Base Caravan - Swift Charisma 565

Adaptation specification

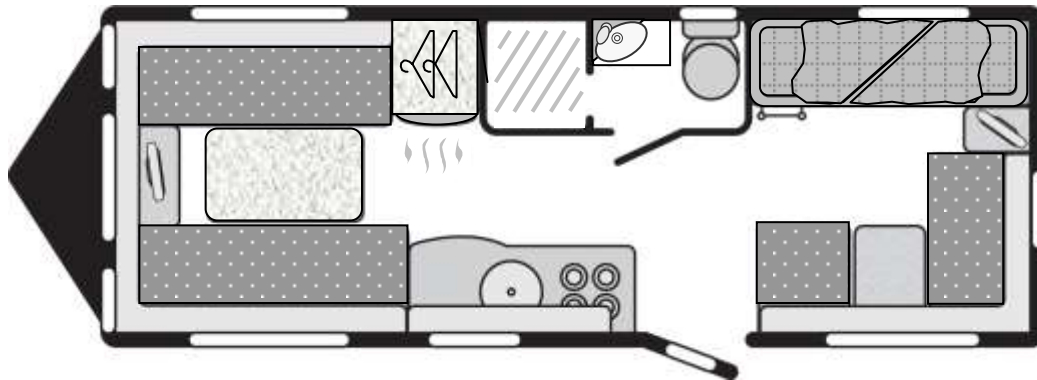
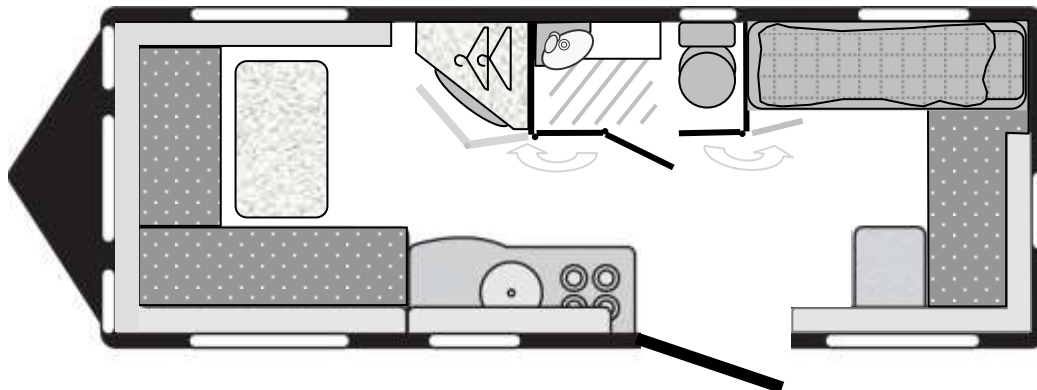
Wide wheelchair access door

Ramp brackets are fitted to the exterior of the caravan allowing the main exterior door to open and close normally whilst the ramps to remain in situ.

The lounge will be converted into an 'L' shaped configuration with a full double bed for the evening. The wardrobe and fire below will be angled to give wheelchair turning clearance and repositioned slightly towards the rear.

A special purpose 'wet room' is created on the offside with integral toilet, hand basin, shower and curtain. The length of the bathroom will be reduced slightly to provide increased wheelchair access to the front lounge area. Bathroom access will be both via a standard door and wide access via a combination of the door and a folding wall sections.

The lower bunk, rear facing dinette seat, rear seat and cupboard will be removed and a new transverse fixed bed/seat

Wheelchair dining can be at either the front folding table or the rear dinette.
